| MINOLTA DYNAX 600si CLASSIC        | (2097–100) |
| MINOLTA MAXXUM 600si               | (2097–300) |

#### PARTS MODIFICATION LIST

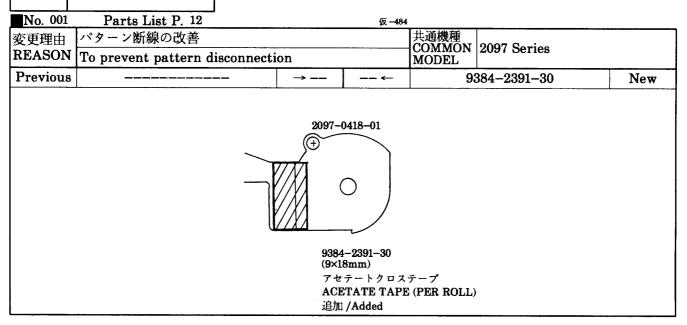
管理 No. 10-2097-002 REF No. No. 002 Parts List P. 12 共通機種 COMMON 2097 Series 生産都合 変更理由 REASON For efficient production MODEL 2097-0418-01 **Previous** 2097-0418-01 New 2097-0418-01 HE THE THE 2097-0418-01 は形状の異なる 2 タイプがあります。
No change in parts No. Discern the type by the shape.

管理No. REF No. QS FA 2155-P004 PARTS MODIFICATION LIST

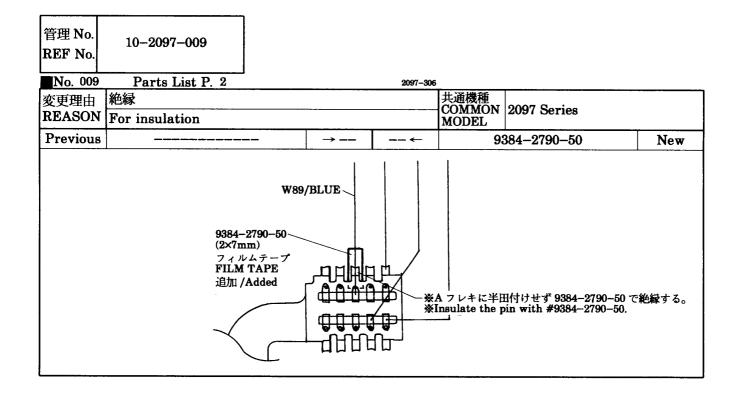
■No. 004 Parts List P. 8 仮-686 共通機種 -ビス用部品として供給 変更理由 **COMMON** 2155 Series REASON Added as <u>a service part</u> MODEL Previous (2017-0493-03)New MIRROR BOX ASSY/ ミラーボックスセット B B-60 (2017-0493-03)SPC-2 (Shaded area) Added/新設 (斜線部)

- SPC-2 #2017-0493-03 is applicable to these models; 2081, 2082, 2084, 2085, 2087, 2089, 2092, 2093, 2094, 2095, 2096, 2097, 2099, 2151, 2152, 2153, 2154, 2155.
- This PML for 2155 represents all models.
- · Application availability is unknown to other models than above.
- ・SPC-2 (2017-0493-03)は以下の機種で共通使用可能です。 但し、PMLは2155のみでの発行とします。 2081, 2082, 2084, 2085, 2087, 2089, 2092, 2093, 2094, 2095, 2096, 2097, 2099, 2151, 2152, 2153, 2154, 2155.
- ・上記機種以外では、未調査です。

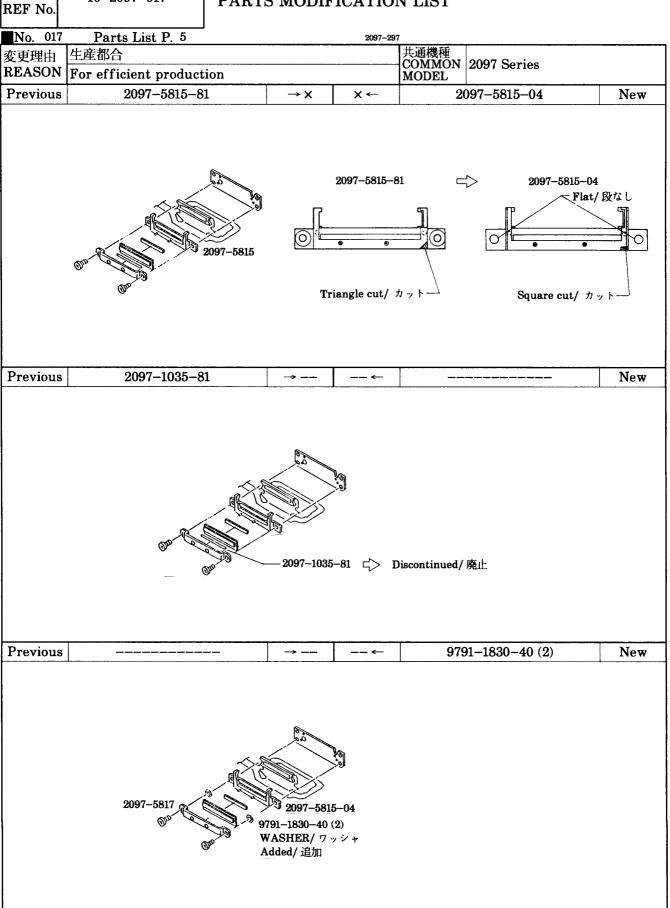
管理 No. 10-2097-015 PARTS MODIFICATION LIST REF No. ■ No. 015 Parts List P. 1, 10 2097-275 共通機種 COMMON 2097-100, -300 裏蓋ロックの改善 変更理由 REASON To improve Back-Cover Release operation MODEL 2097-0110-01 New **Previous** 2097-0110-02 **×** ← P. 10 2097-0110-01 2097-0110-02 2097-0110 P. 10 **Previous** 2089-0121-01 2089-0121-01 New P. 1 2089-0121-01 斜線部をカットする Cut off the shaded part. |カットしない Do not cut the shaded part.

管理 No. 10-2097-016 PARTS MODIFICATION LIST REF No. No. 016 Parts List P. 1, 11 2097-275 共通機種 COMMON 2097-200, -600, -800 裏蓋ロックの改善 変更理由 REASON To improve Back-Cover Release operation MODEL **Previous** 2097-0109-01 2097-0109-02 New × ← P. 11 2097-0109-01 2097-0109-02 2097-0109 P. 11 **Previous** 2089-0121-01 2089-0121-01 New P. 1 2089-0121-01 カットしない Do not cut the shaded part. 斜線部をカットする Cut off the shaded part.

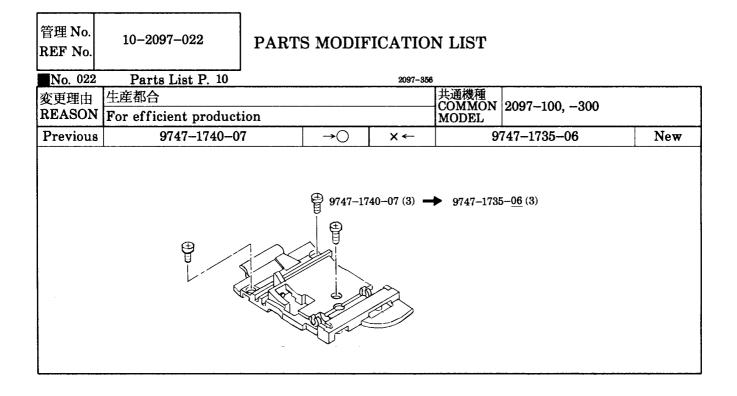
| No. 020<br>変更理由<br>REASON | パノラマファインダー遮光板作動の改善 |    |    | 共通機種<br>COMMON<br>MODEL |              |     |
| Previous                  | 2097-0277-01       | →○ | ×← | <del> </del>            | 097-0277-02  | New |

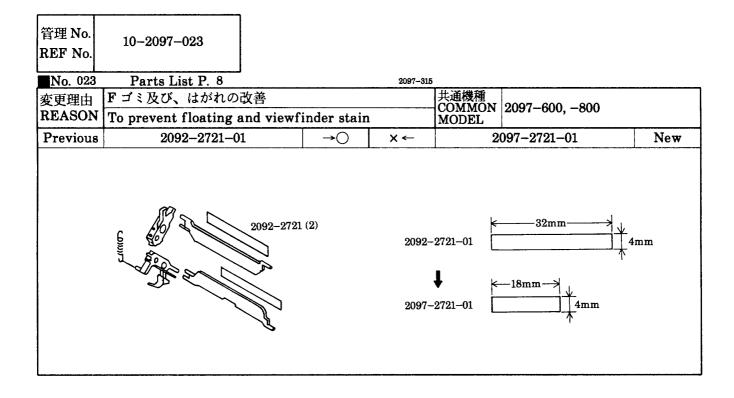
管理 No. 10-2097-021 REF No. ■ No. 021 Parts List P. 5 AEL 釦作動改善 変更理由 REASON To improve operation 2097-1401-04 **Previous** 2097-1401-04 Type-1/タイプ-1

2097-354 共通機種 COMMON 2097 Series MODEL → x **x** ← 2097-1401-04 New 2097-1401-04 Type-2/ タイプ -2 H=0.25mm **Previous** 2097-1039-81 New FPC-N/N フレキ 2097-1039-81 Added/ 追加 \*Cut the 2097-1039-81 into the size 2097-1401-04 of 1.5×1.5mm to affix. ※2097-1039-81 を (L5×1.5mm) にカット して貼り付けて下さい。 ・部品 No. の更新はしません。 ・タイプ -1 にのみ 2097-1039-81 を貼り付けて下さい。 ・No change in parts No.

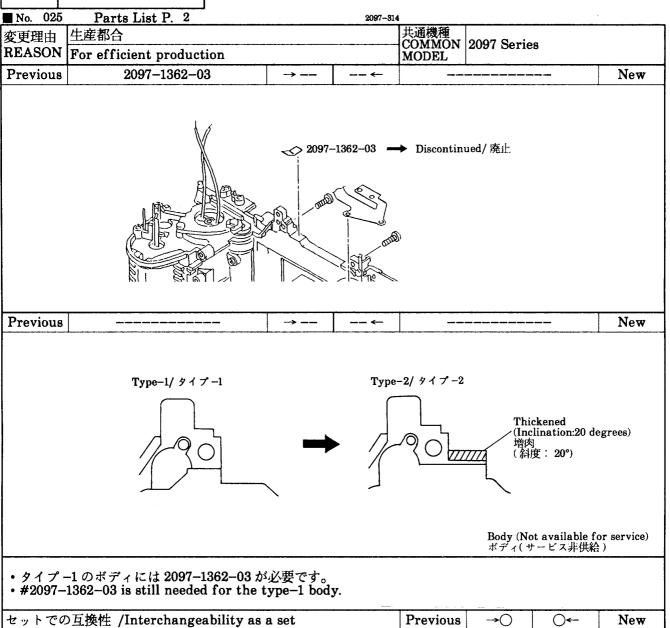
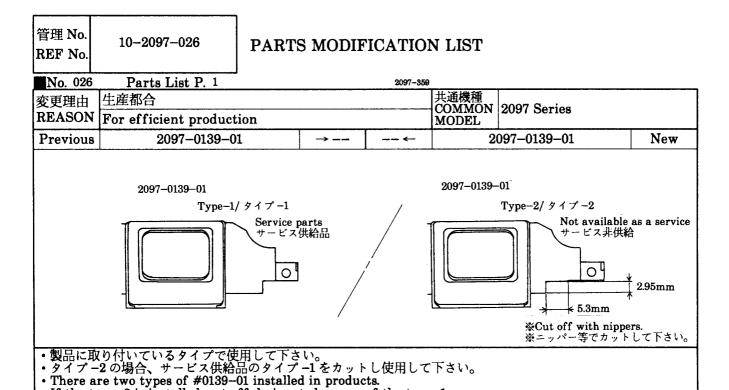
No. 024 Parts List P. 1 2097-314 共通機種 COMMON MODEL 2097 Series 生産都合 変更理由 REASON For efficient production 2089-1618-01 **Previous** New 2089-1618-01 **Discontinued/廃止** Previous New Type-1/ タイプ -1 Type-2/ タイプ-2 Body (Not available for service) ボディ(サービス非供給) タイプ-1のボディには 2089-1618-01 が必要です。
#2089-1618-01 is still needed for the type-1 body. セットでの互換性 /Interchangeability as a set Previous →() **○←** New

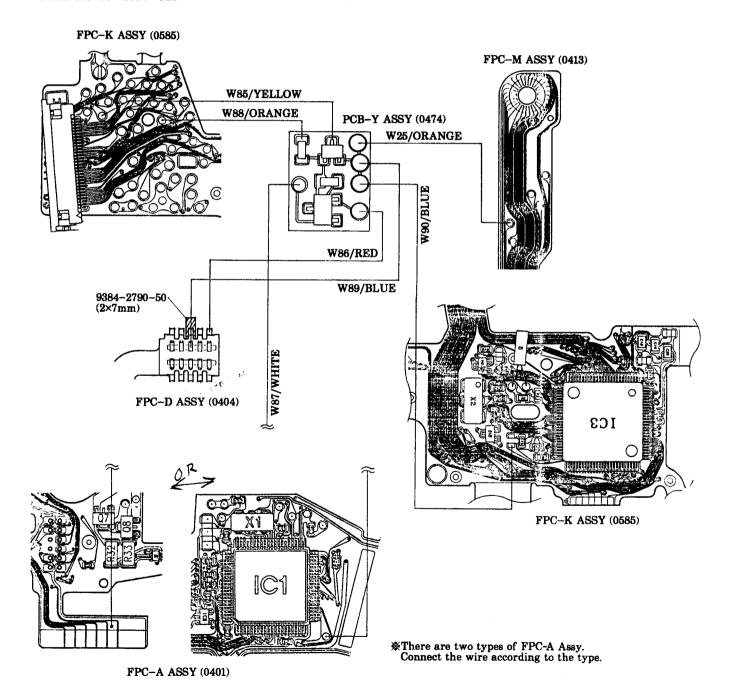
■Change of wiring accompanied with PCB-Y Assy modification (2097-0472-01 → 2097-0474-01).

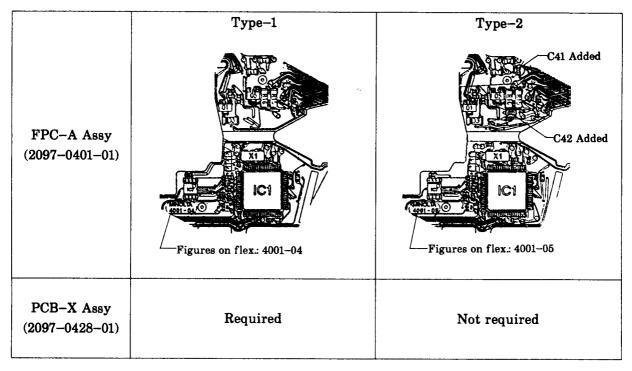
Combination of FPC-A Assy, PCB-Y Assy and R8 (accompanied with FPC-A Assy modification; 2097-0401-01 → -02)

|  | -01                                       | 02  |
|--|---|---|
| R8 on FPC-K assy (9431-1026-67)  *R8 is on or not on the FPC-K Assy for service parts. Check existence of R8 before replacement. | R8 : Not required  **Remove R8 if exists. | R8; Required  *Install R8 when not exist. |
